Input Data

Highway Network

Amendment 3

Figure 1: Lane Change between 2019 and 2050 for Model v8.3.2 2022-02-04.

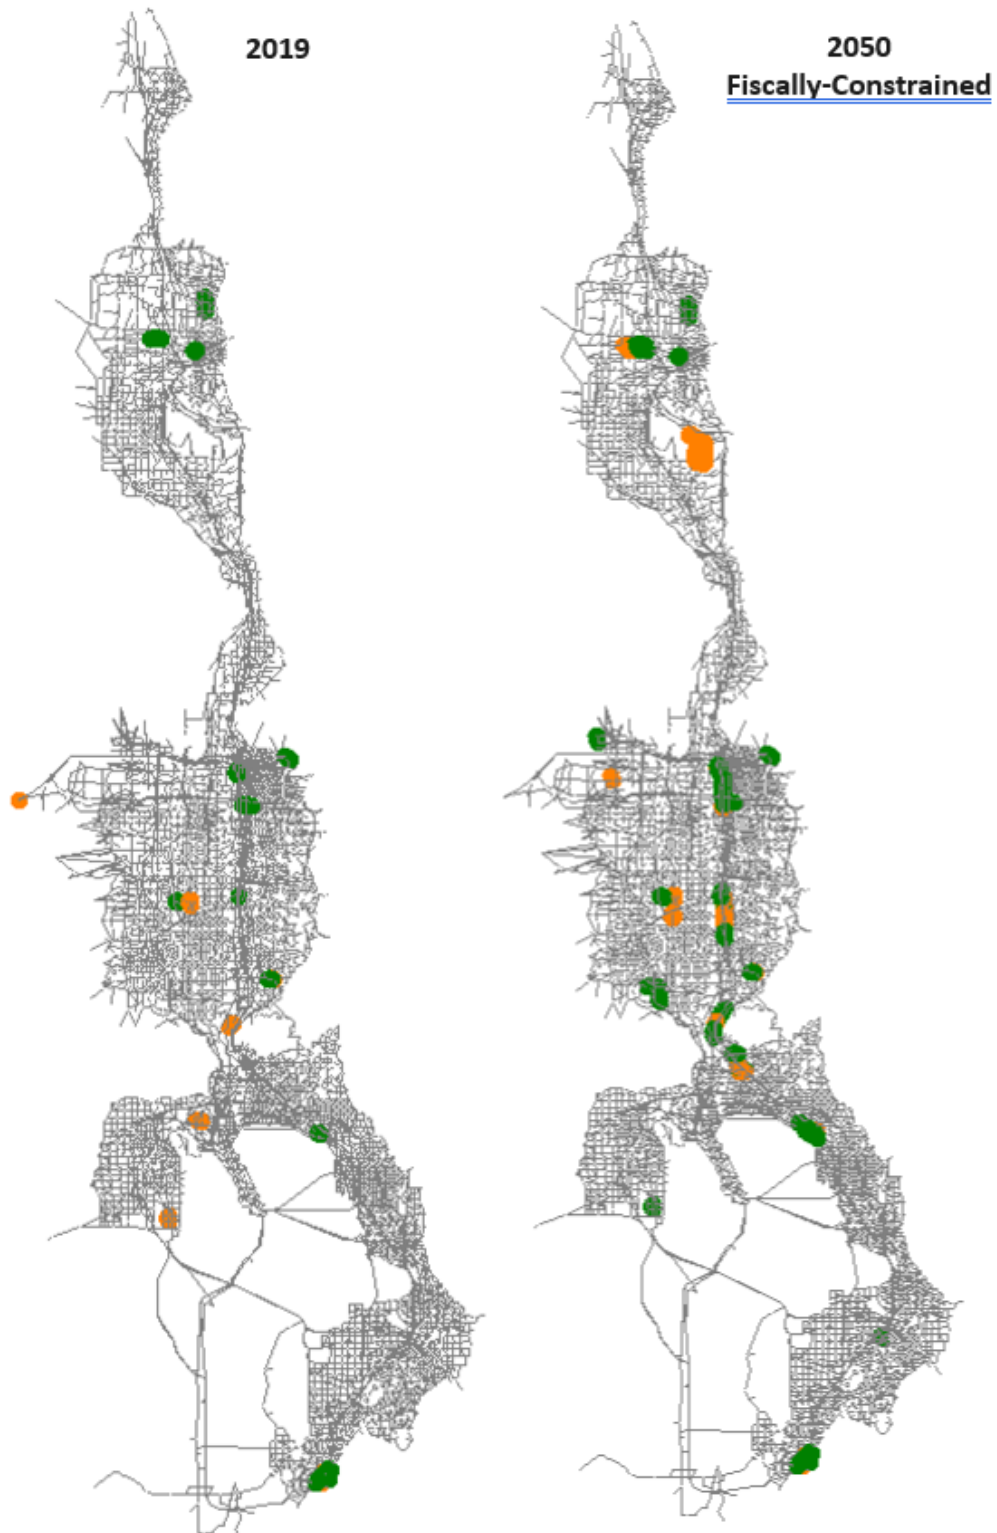
The highway network was updated in the MAG and WFRC areas to reflect the third round of Regional Transportation Plan (RTP) amendments. Additional edits were made in the MAG area to conform with more recent project clarification. Figure 1 shows where lanes were added (green) or were taken away (orange) between versions 8.3 and 8.3.1 highway networks.

Figure 2: Change in Transit Speeds for LRT in Salt Lake County. Green: Increase in Speeds
— Red: Decrease in Speeds.

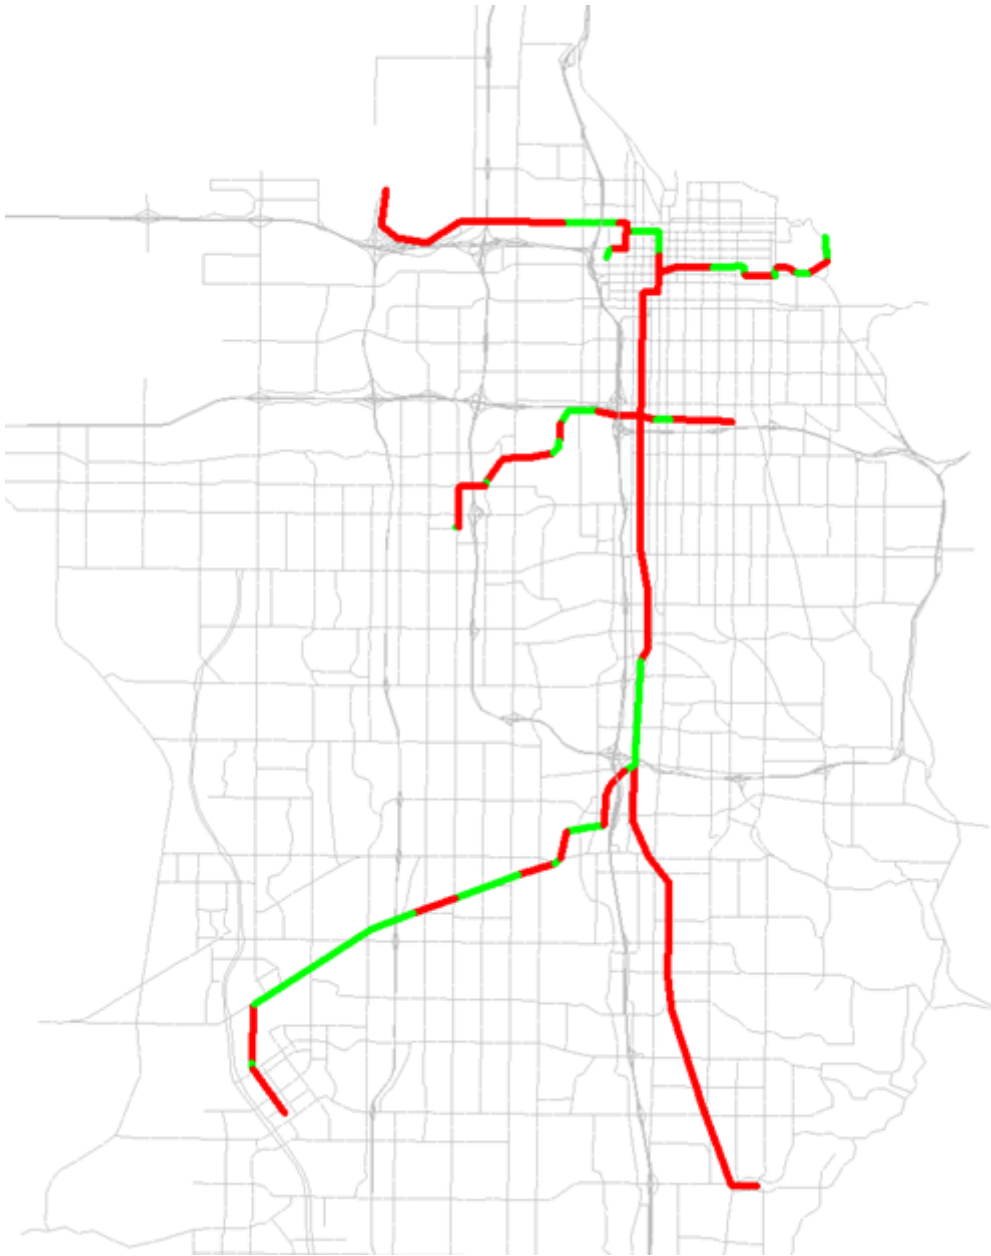
The speed of rail transit is coded onto rail-only links within the master highway network. Transit speed for LRT were updated to reflect 2019 operations. Most of the speed changes were less than 5 mph. Figure 2 shows where light rail speeds were changed.

tbl-lrt-speed shows the resulting average speeds along entire light rail routes. The net effect of the update was generally lower speeds, with the TRAX-Blue line and the S-Line having the largest drops in speed with a drop of 8.2% and 14.5%, respectively.

Figure 3: Hand-Coded Walk Access Links.

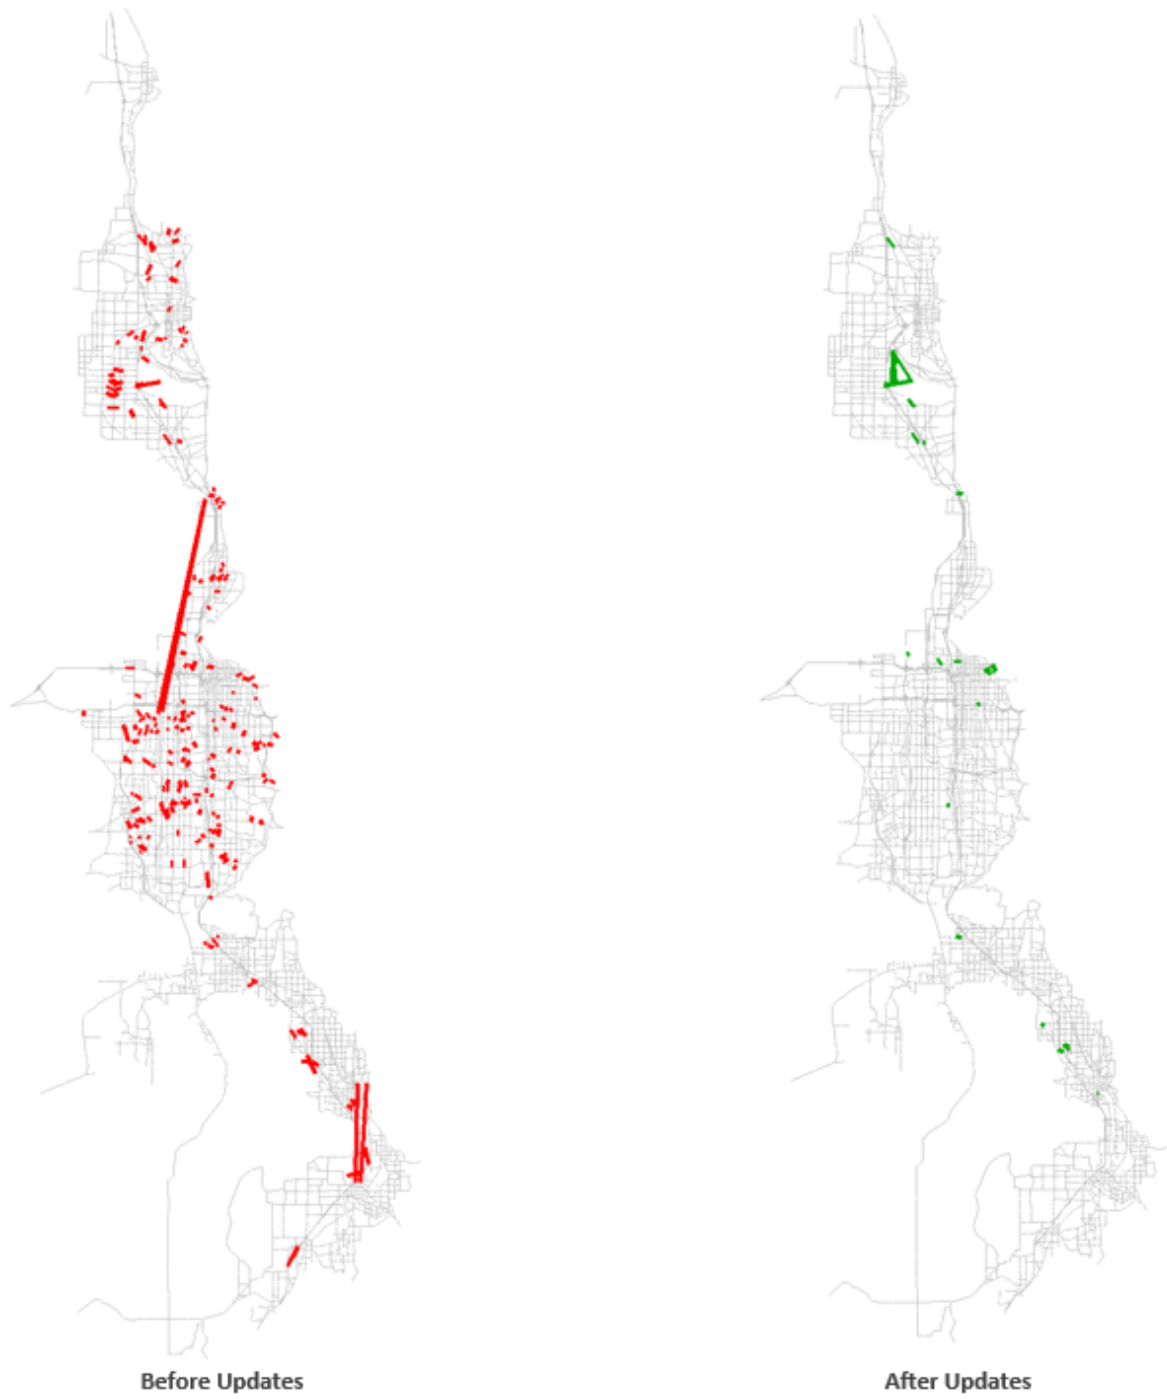
The update process removed a majority of the general hand-coded walk access links, reducing the number from 234 to 31 links. Areas that retained or added hand-coded links include SLC International Airport, Hill Air Force Base, University of Utah, and Utah Valley University. Figure 3 shows hand-coded walk-access links before and after the updates.

Figure 4: Park-And-Ride Lots. *Red: Removed* — *Green: Added* — *Blue: Modified*

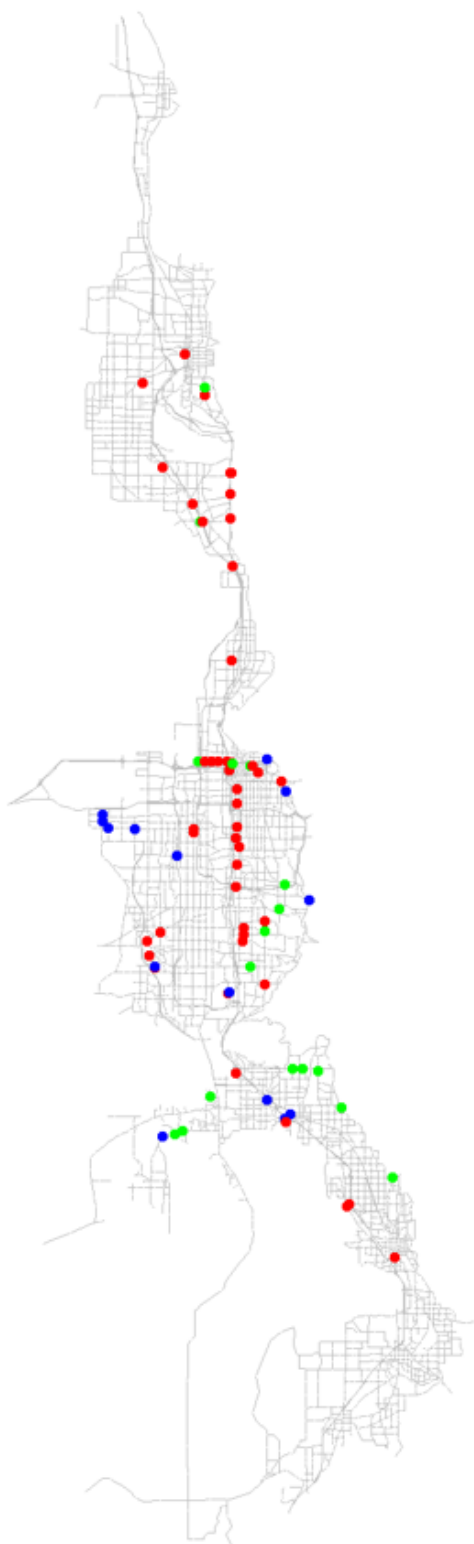
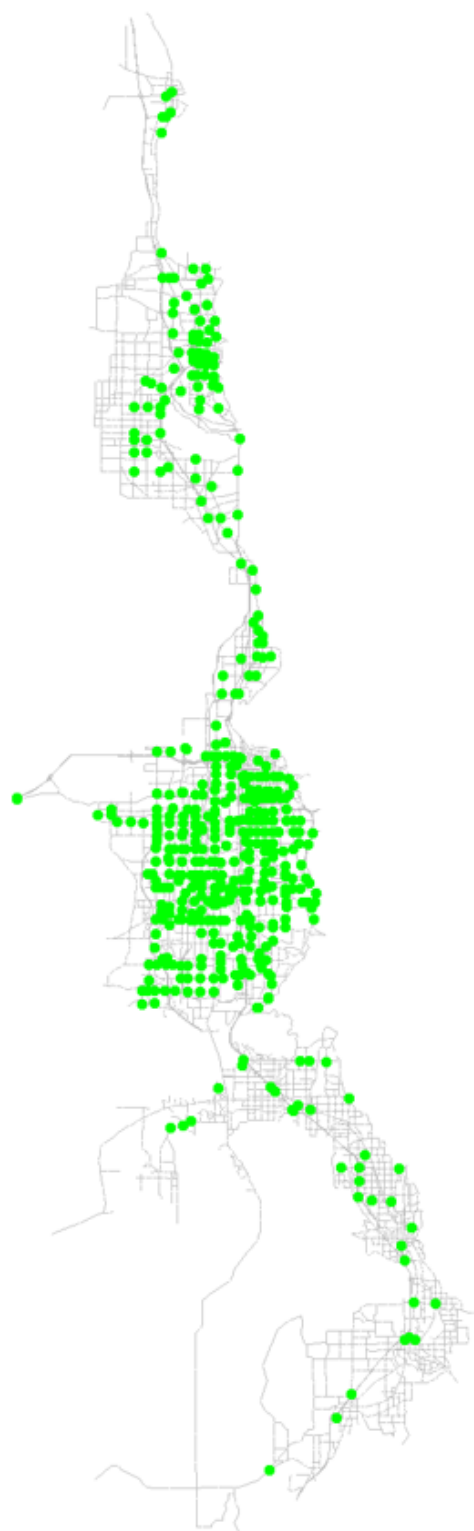
Park-and-Ride lots are coded onto nodes within the master highway network and are defined by what transit mode they service. To be used by the travel model, park-and-ride nodes need to be coded at nodes that serve as rail or bus stops. Figure 4a shows what changes were

made to park-and-ride lots, which include 17 additional locations, 49 removed locations, and 14 locations that were modified by changing the mode they service. Most of the park-and-ride lots removals were due to redundancy on highway nodes adjacent to another park-and-ride lot at a rail node. The park-and-ride lots additions mostly included new lots along express bus routes. The resulting park-and-ride lot locations, including ones that were not edited, are shown in Figure 4b.
